**ATTACHMENT 2 –  
CORRESPONDENCE FROM  
RAILCORP**

**STATE ENVIRONMENTAL PLANNING POLICY (INFRASTRUCTURE) 2007  
DEVELOPMENT APPLICATION – DA-1281/2010  
Lot 1 Speed Street, Liverpool**

**STATE ENVIRONMENTAL PLANNING POLICY (INFRASTRUCTURE) 2007  
DEVELOPMENT APPLICATION – DA-1281/2010  
Lot 1 Speed Street, Liverpool**

**PART BASMENT L2 PLAN - RAILWAY PRECINCT INTERFACE**

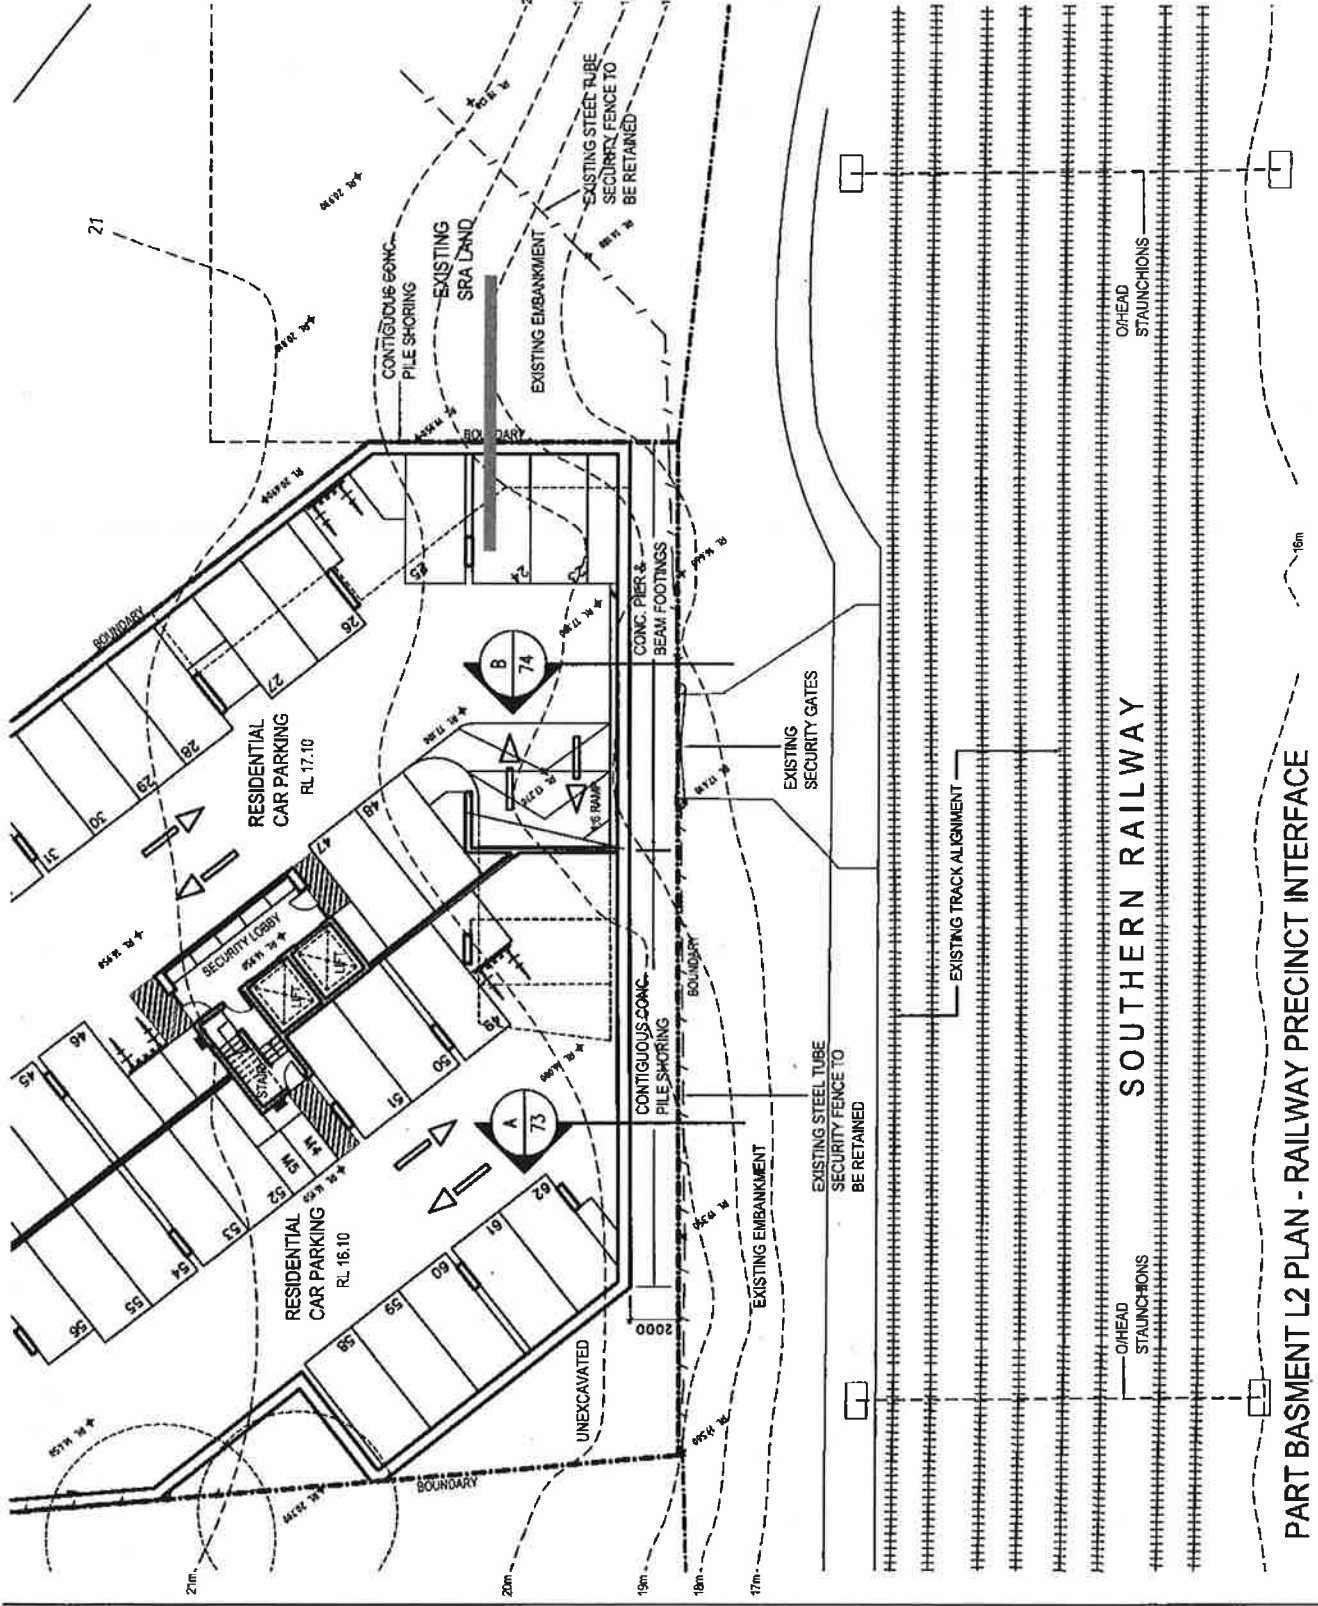
RailCorp has identified that the proposal includes drainage works within RailCorp's land to which RailCorp approval has not been obtained (refer to Attachment B highlighting). RailCorp requests that these proposed drainage works be removed from the application.

RailCorp has also identified an anomaly between the drainage plans and the most recent drawings provided to RailCorp. The drainage plans indicate basement works abutting the common boundary on the south-eastern side of the site whereas the most recent cross sectional drawings indicate a setback of 2m. RailCorp requests that it be provided with the most recent correct drawings.
